**CITY OF AUSTIN**  
**Board of Adjustment/Sign Review Board**  
**Decision Sheet**

**CASE NUMBER:** C15-2010-0103

**ADDRESS:** 2505 LONGVIEW ST

CITY OF AUSTIN – WATERSHED PROTECTION AND DEVELOPMENT REVIEW DEPARTMENT  
SITE PLAN APPLICATION – MASTER COMMENT REPORT

FRONT STREET FRONT ELEVATION

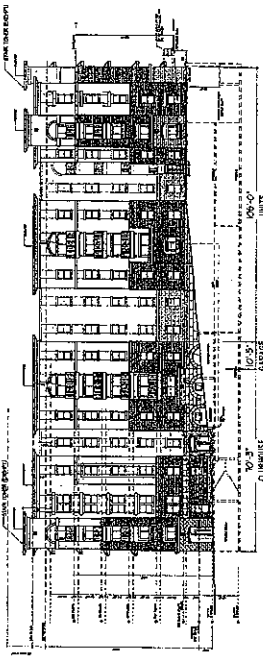
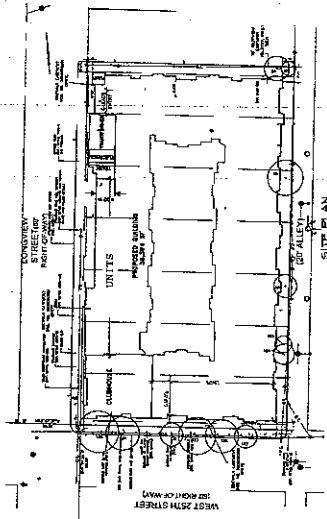
SP 2 Please demonstrate compliance with Section 25-2-758 - the exterior wall facing W. 25<sup>th</sup> Street must be setback from the lower portion of the wall by a distance of at least 12 feet for the portion that is over 60 ft. Show this on sheet 25 – Architectural Elevations.

*U1. Reviewer found no changes on sheet 25 – please demonstrate compliance.*
